What we heard report

Stage 1 public consultation: Draft Lachlan Valley Floodplain Management Plan

September 2026

Figures 15 to 19 provide an overview of refinements made to the identified flood-dependent ecological assets in response to stakeholder feedback.

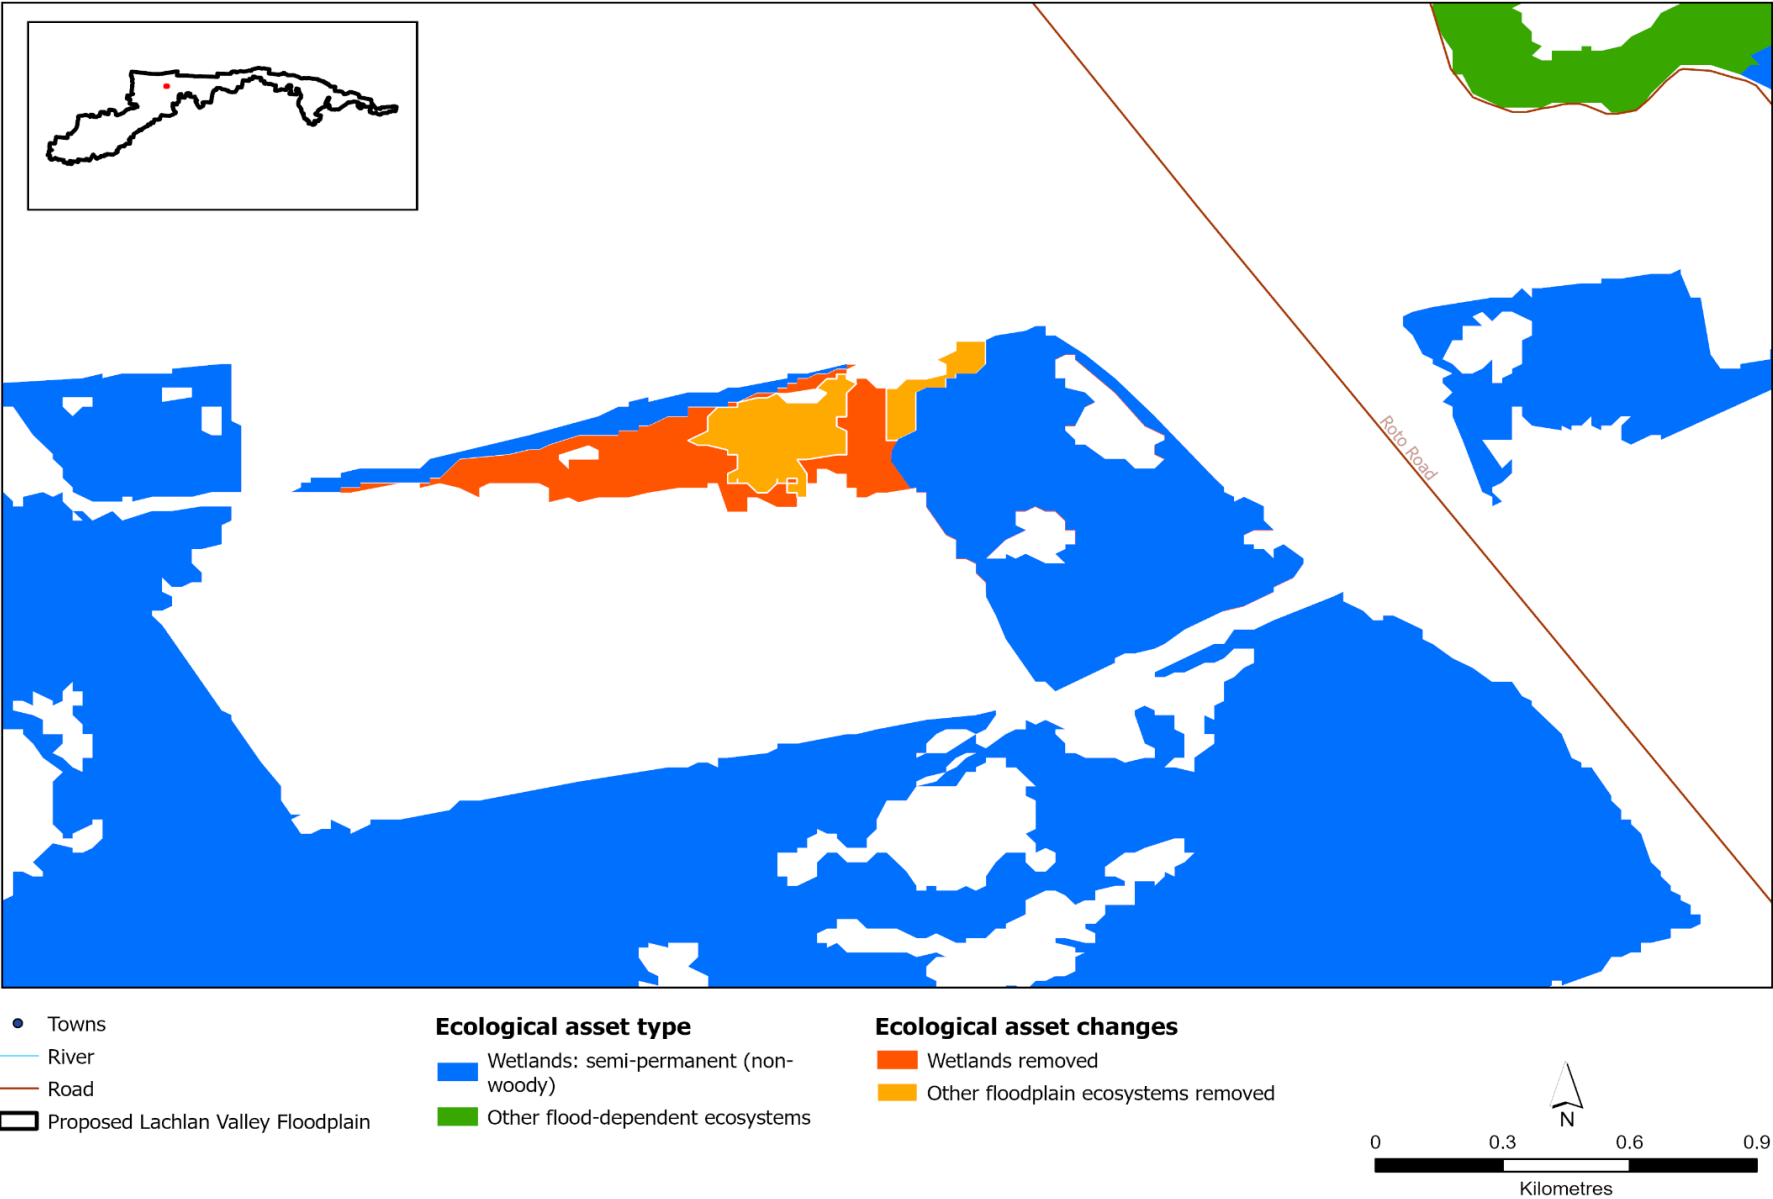
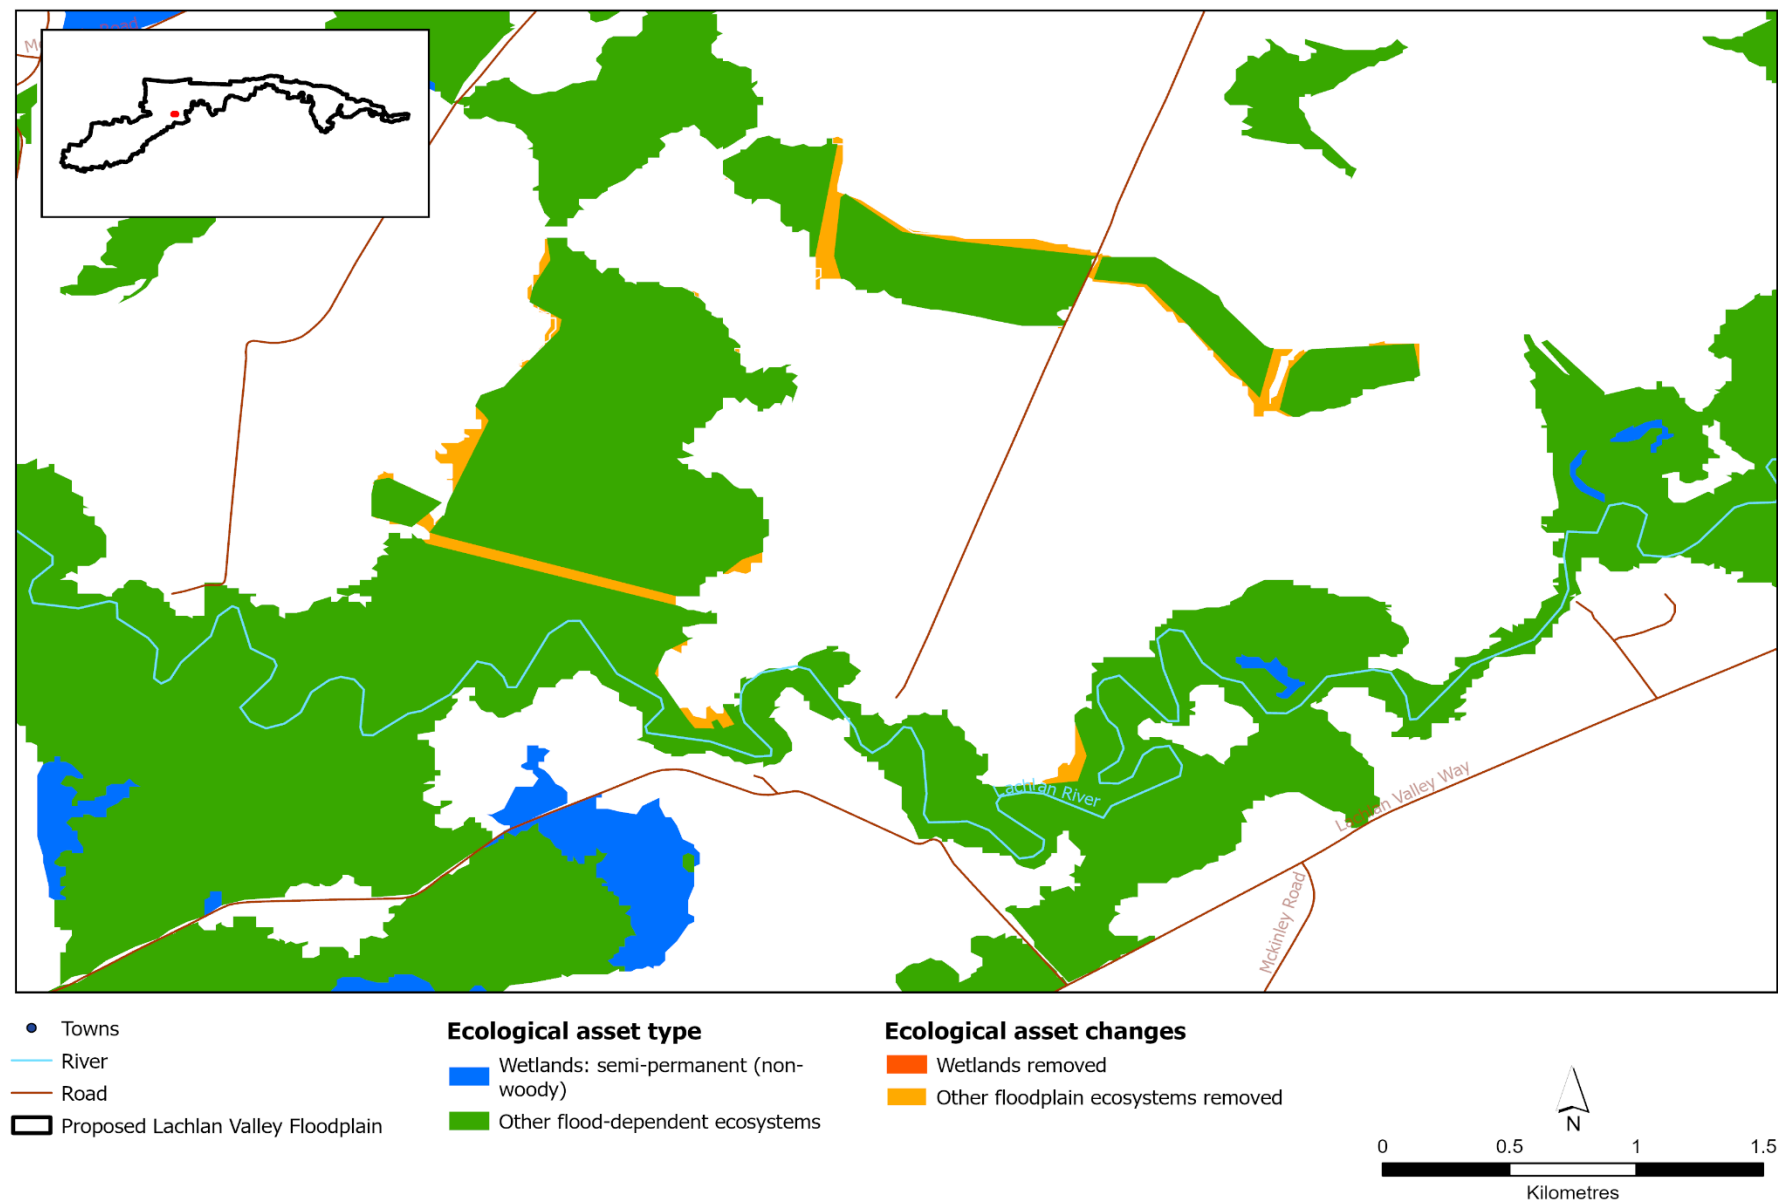
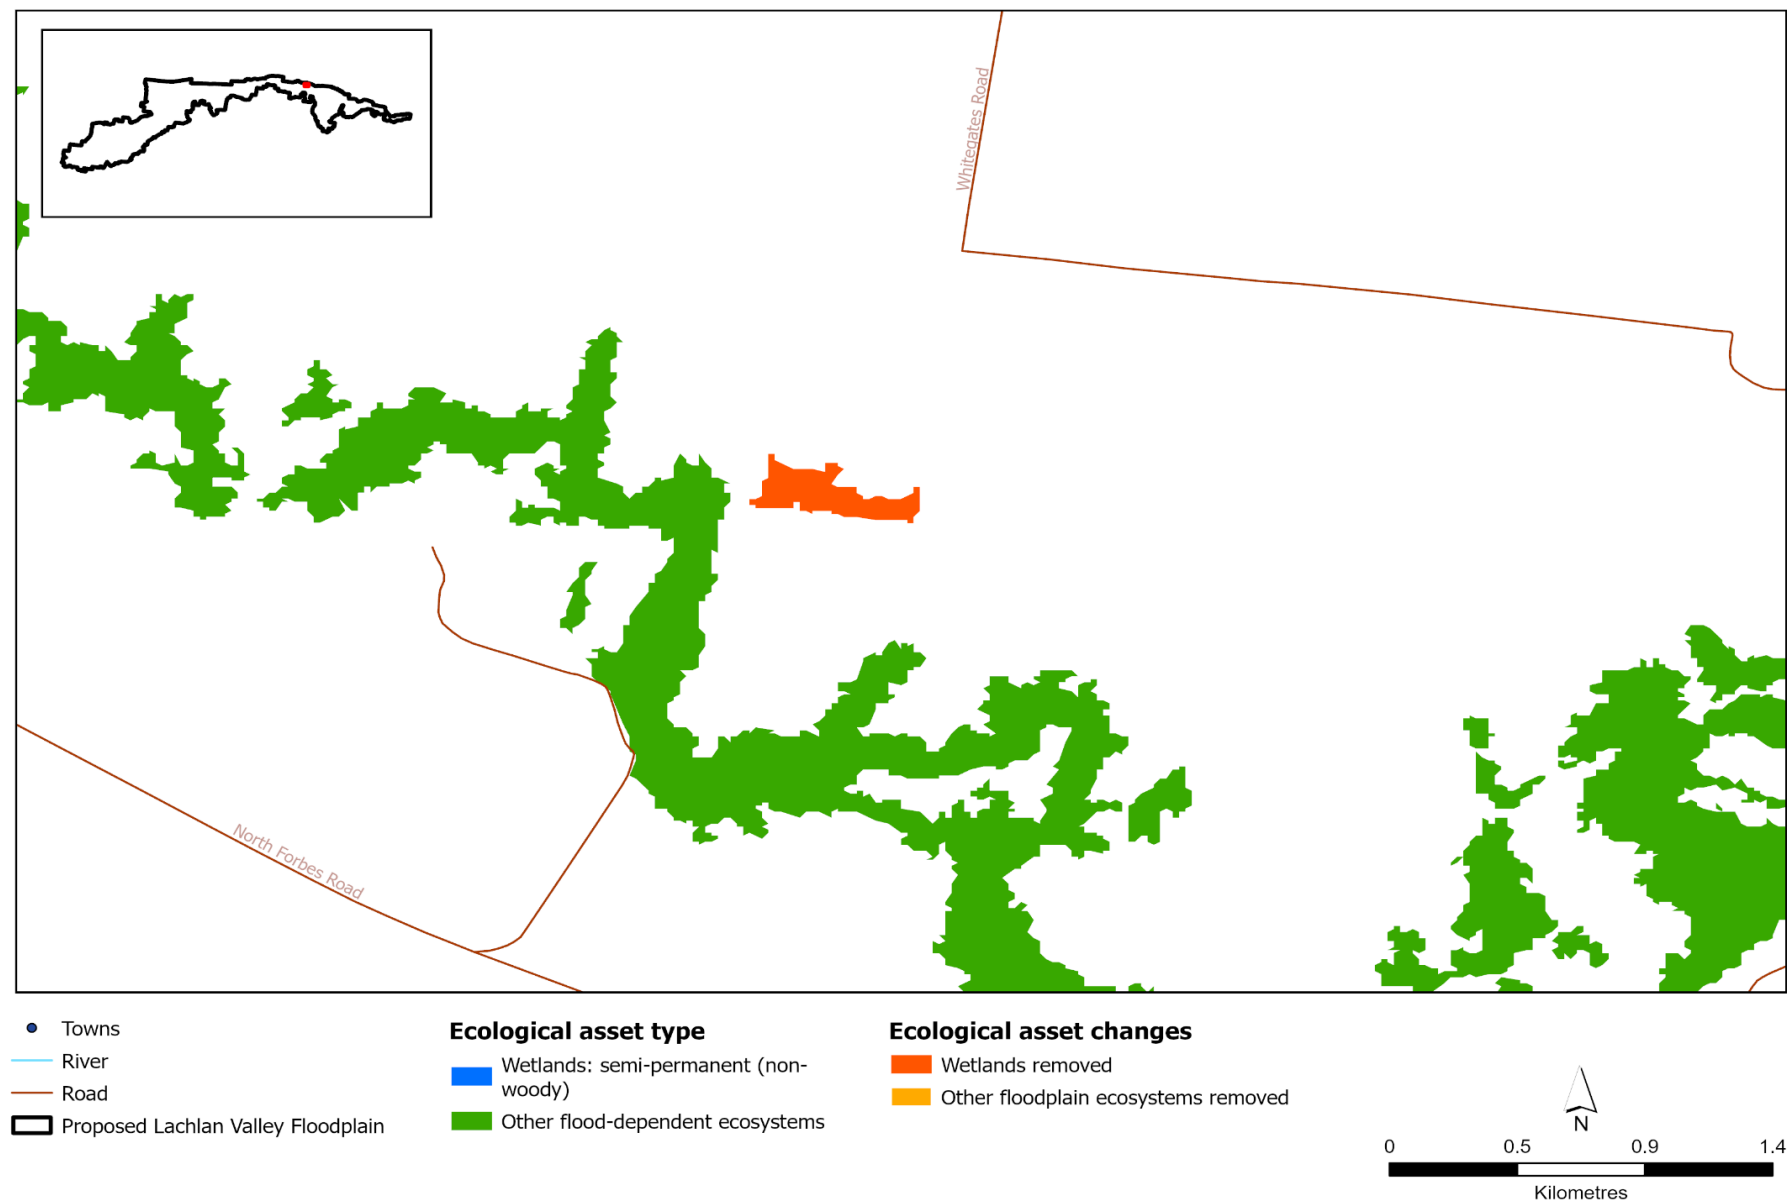
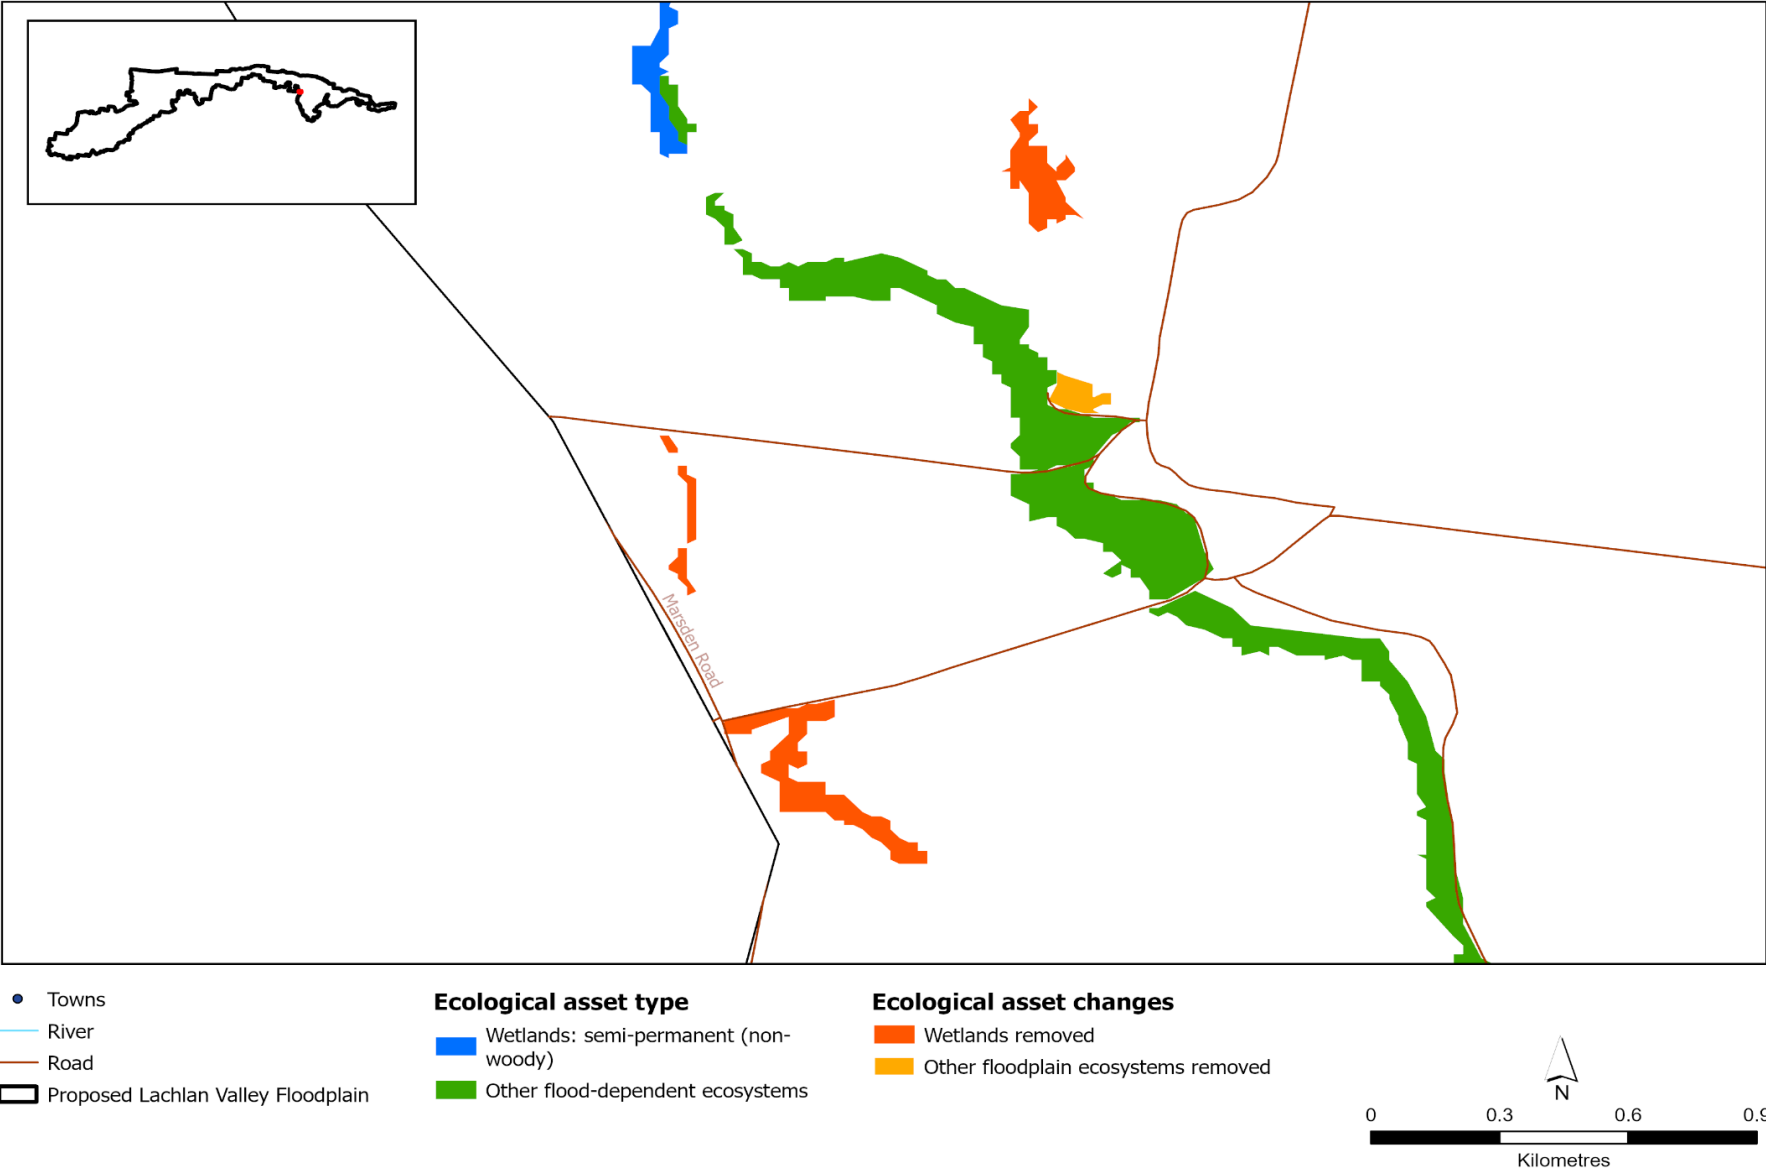
Disagree with the identified ecological assets on my property.	Significant feedback was received regarding mapping inaccuracies. In response to this feedback, we have made over 400 spatial refinements. Refinements to ecological assets are shown in Figures 15 to 19 in Appendix 2. More information about the ecological asset identification and categorisation is available in the Report to assist Stage 1 public consultation.
Ecological assets mapping appears to show flood dependant ecological assets in areas that overlap with existing irrigation infrastructure and does not distinguish between natural ecosystems and areas that are part of managed water delivery systems.	See response above.
